MODEL 41119

**SET-UP
&
SERVICE INFORMATION**
CONTROL VALVE SUPPORT BRACKETS
 NOTIFICATION OF CHANGE IN TORQUE SPECIFICATIONS

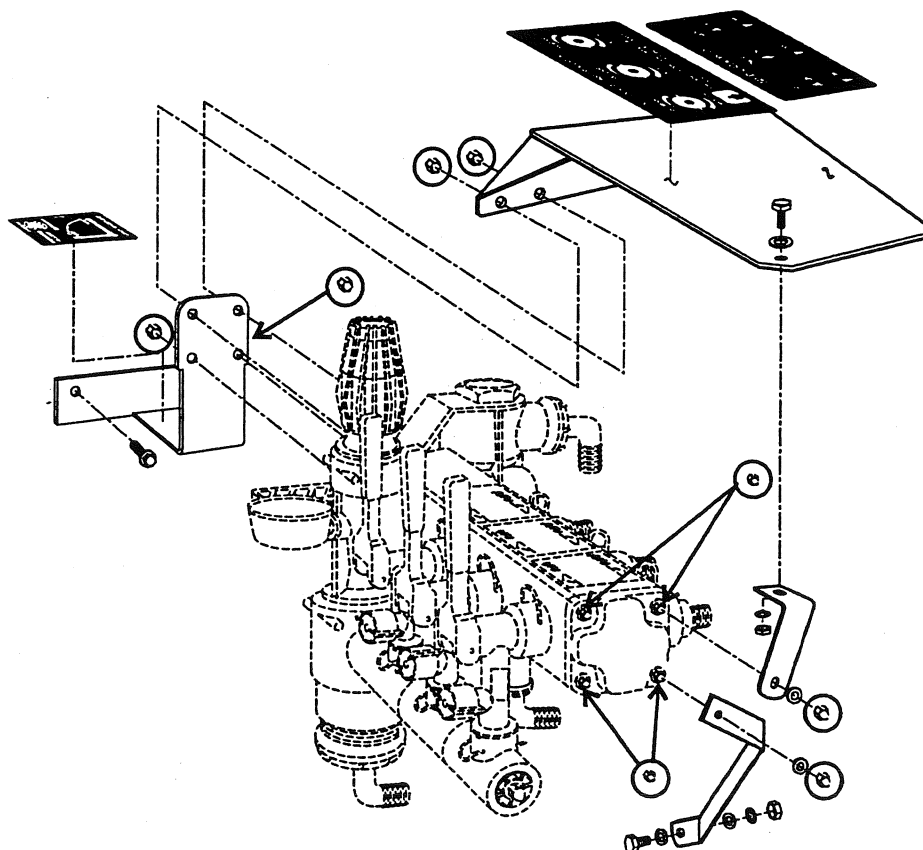
CAUTION: WHEN ASSEMBLING SUPPORT BRACKETS TO THE CONTROL VALVE THE ACORN AND HEX NUTS MARKED ABOVE ARE NOT TO BE TORQUED OVER 30 IN LBS (3.4NM), APPLY LOCTITE* TO THE ACORN NUTS ONLY.

OVER TORQUING MAY DISTORT THE PIPE FITTING, RESULTING IN LEAKAGE FROM THE VALVE.
